SUBJECT: **Addendum No. 1**  
Union County Public Schools  
Walkway Canopy Projects

**UNION COUNTY  
PUBLIC SCHOOLS  
2018 CANOPIES**

ABDI-01

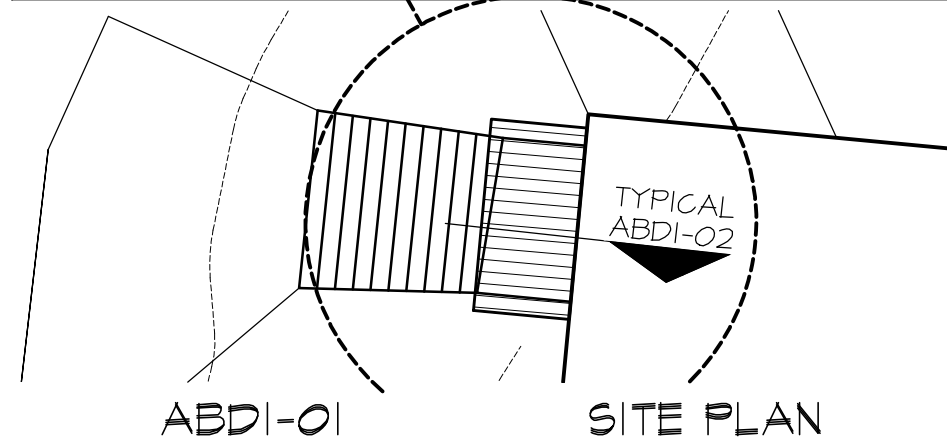
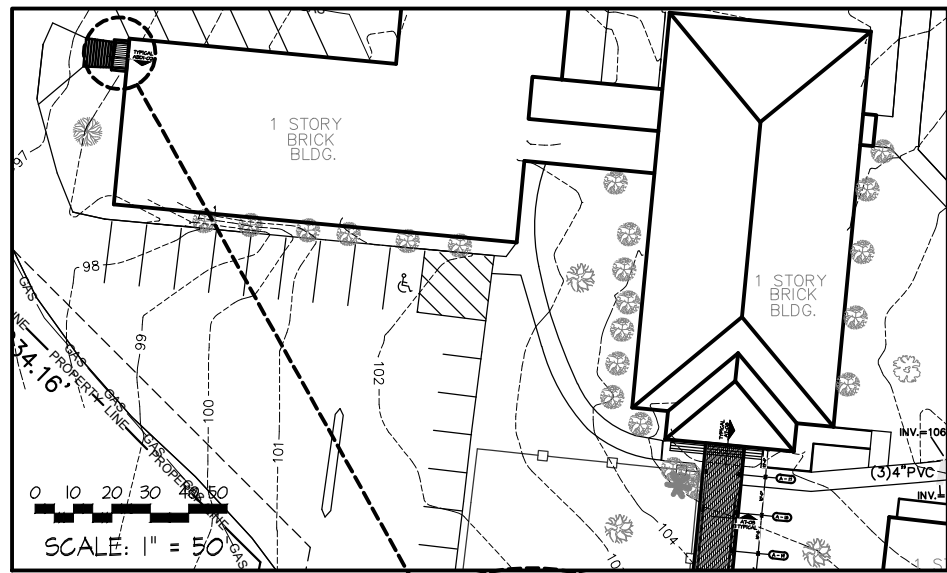
**ITEM #03: Reference Drawing Sheets A1.1 SITE PLAN; A2.1 – ENLARGED PLAN:**

Bus canopy section at Indian Trail Elementary School is revised and entrance canopy added as shown on attached Bulletin Drawing ABD1.

ABDI-02

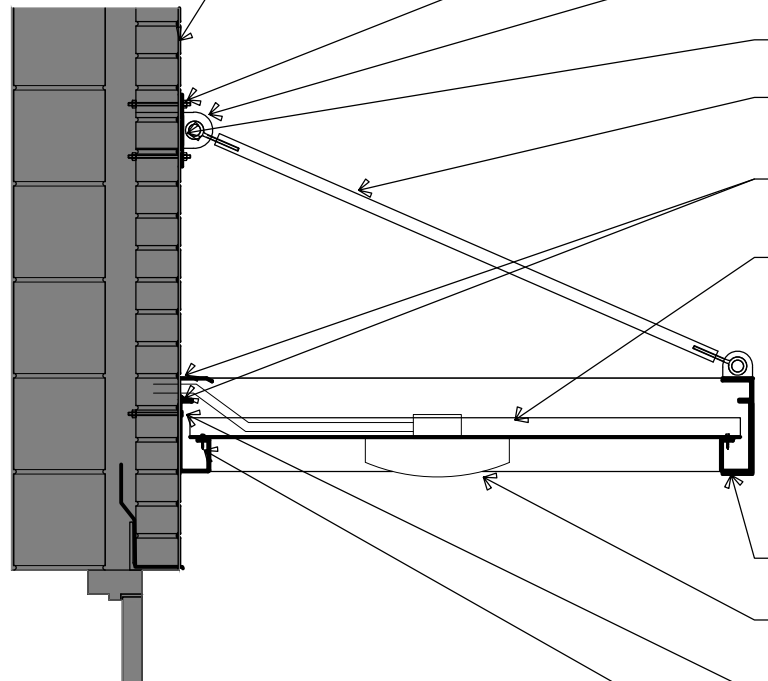
Canopy light fixture quantity and layout shall be adjusted per Architectural Bulletin Drawing ABD1. Add a net total of three (3) light fixtures, including one (1) shown per ABD1-02 for suspended canopy. Power suspended canopy fixture to spare circuit via PE cell per plan note 1.

SUPPORT AND SECURE NEW CANOPY TO EXISTING WALL AS REQUIRED

CANOPY BODY ALUMINUM: COMPLETE ASSEMBLY, INCLUDING FASCIA AND INTEGRATED PERIMETER GUTTER WITH SCUPPERS. TYPICAL WHITE ALUMINUM FINISH.
